CITY OF LAKEWOOD
LAKEWOOD TOWN SQUARE
CIP PROJ. NO. P2CC2623; BID NO. PW24-07

ADDENDUM NO.1

ADDENDUM NO. 1

PROJECT TITLE: LAKEWOOD TOWN SQUARE

SHEET
A511

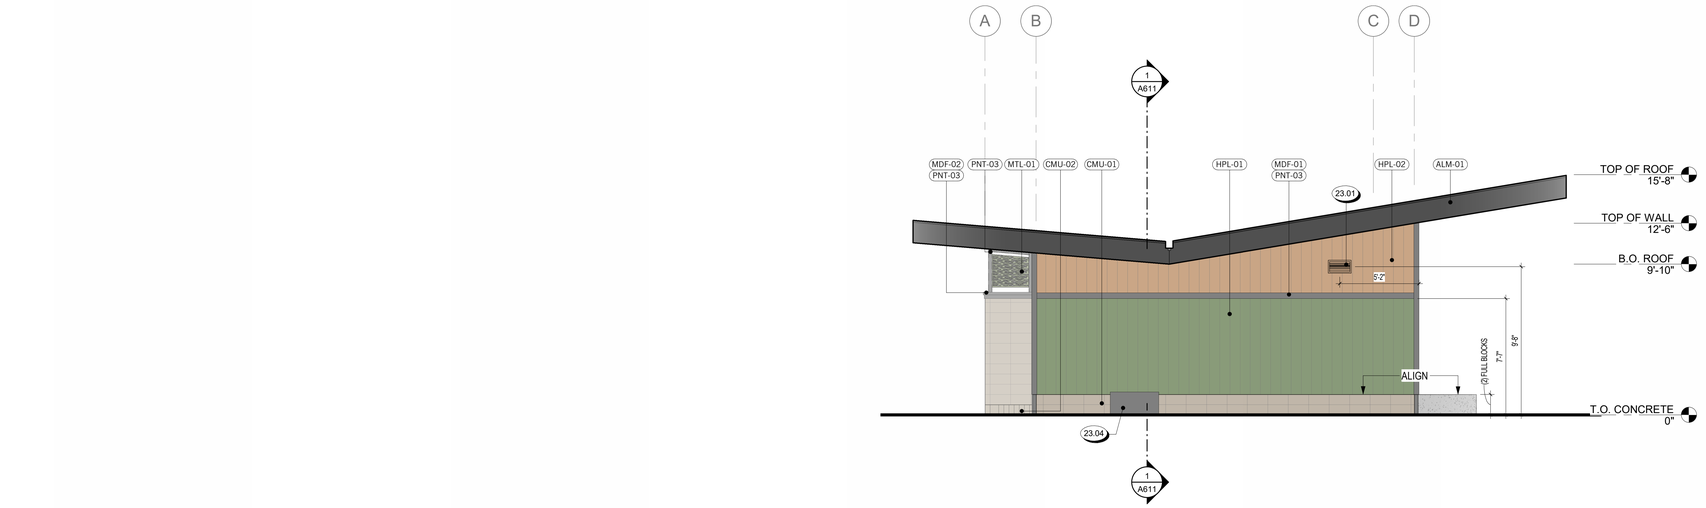
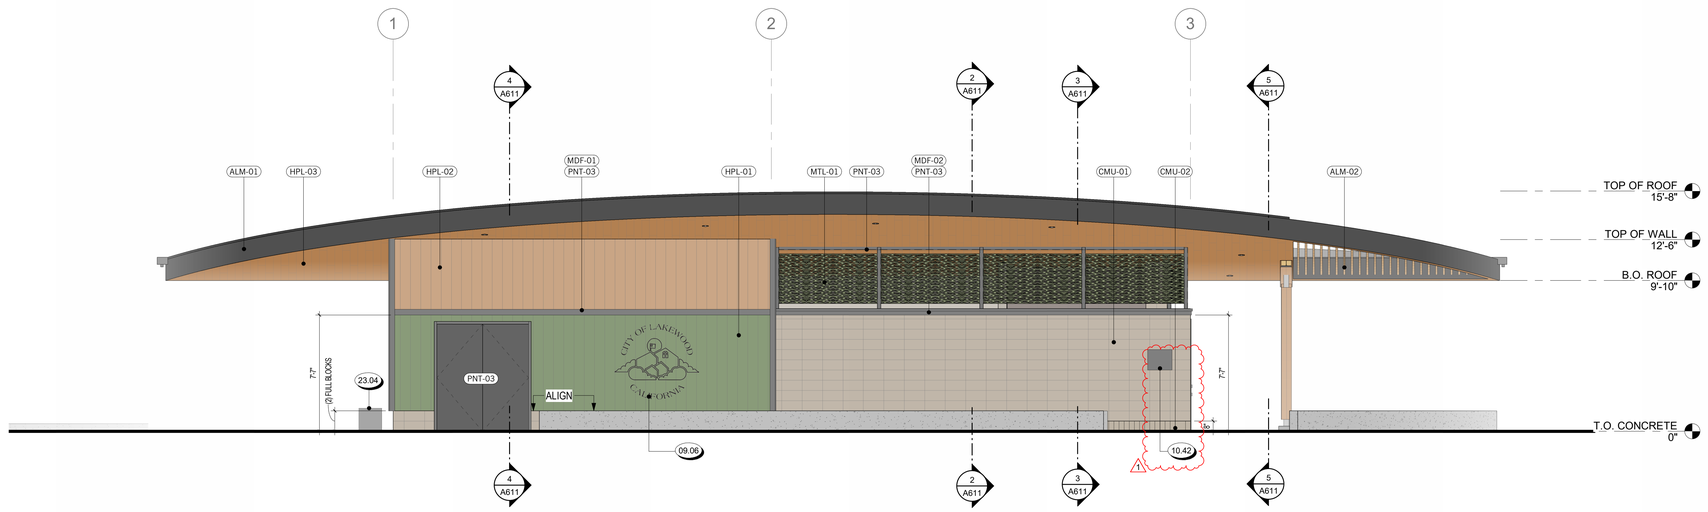
A6	**Please see Addendum 1 for revision to C3.00. 2" pipe has been revised to 4"**
Q7	Keynote 09.06 is missing a description in the keynote legend on Sheet A511. Please clarify the scope of work associated with this keynote.
A7	**Please see Addendum 1 for revision to A511.**

A13	**Please see Addendum 1 for revision to A211 and A511.**
Q14	Please confirm whether the City will accept a single umbrella/excess liability policy covering General Liability, Automobile Liability, and Employer's Liability to satisfy the required

SHEET
A512

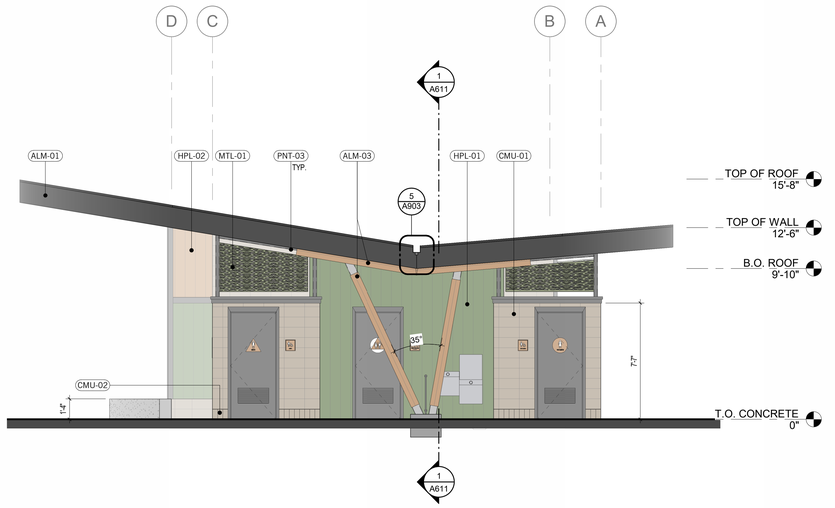
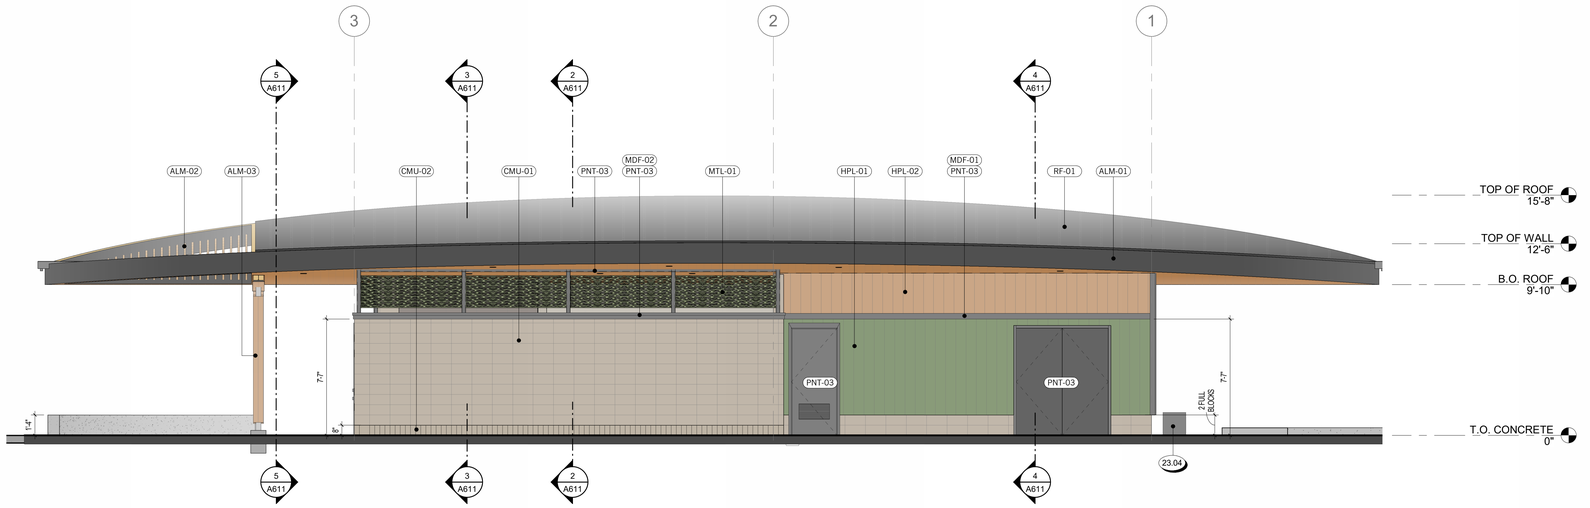
A3	**Please see Addendum 1 for revision to A211. 10.43 has been changed to 10.45 and has been moved to A101.**
Q4	Keynote 10.44 is missing a description in the keynote legend on Sheet A211and A512. Please clarify the scope of work associated with this keynote
A4	**Please see Addendum 1 for revision to A211 and A512. 10.44 has been changed to 10.46.**
Q5	Keynote 10.42 is missing a description in the keynote legend on Sheet A511. Please clarify the scope of work associated with this keynote.
A5	**Please see Addendum 1 for revision to A512.**
Q6	Grading Construction Note 35 on Sheet C3.00 calls for 2" SDR-35 PVC storm drain pipe at the planter drain connections to the 12" SDR-35 storm drain main. SDR-35 PVC per ASTM D3034 is manufactured in 4" through 15" only. 2" SDR-35 is not available. Note 36 calls for 12" x 2" x 12" PVC tee which is also not a standard fitting. Please confirm the following: 1. Size and material for note 35: 2" Schedule 40 PVC, 4" SDR-35 or otherwise 2. Acceptable connection of the lateral to the 12" SDR-35 main in place of the Note 36 tee.

SHEET
LD-02

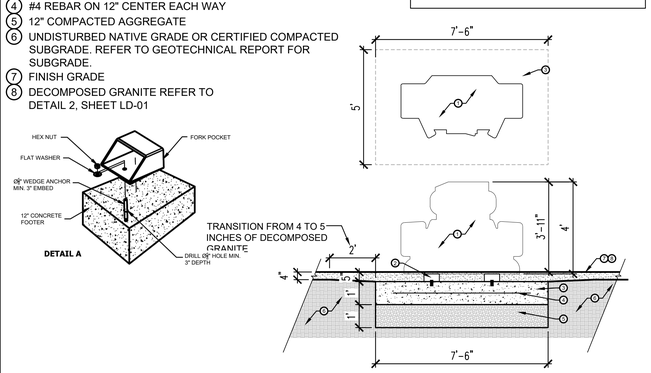
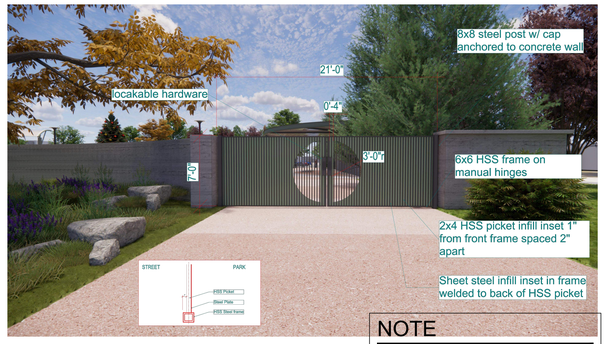
Q8	Sign per 3/LD-02 - Please provide dimensions – width, height, depth of the cabinet. Height and returns of the letters. Dimensions of the digital display. Is the undercarriage aluminum or steel?
A8	**Monument sign in question has been removed from project scope. Refer to Addendum 1 for updated drawing sheets.**
Q9	Detail 21/A901 – Is there signage, such as park rules, or informational. Please clarify the scope of work associated with this Detail.
A9	**Please refer to A101 for locations of (3) pole mouneted park sign locations per keynote 10.45 (originally 10.43).**
Q10	Alternate No. 1 – Proposal Form Section 01 23 00 lists Alternate No. 1 for replacing the interlocking pavers with integral-colored concrete, as shown on Sheet LC-02. The Proposal Bid Sheets do not include a separate line for this alternate. Please confirm how bidders should submit its price, whether it should be shown as a net add or deduct from the base bid, and whether an updated proposal form will be issued.
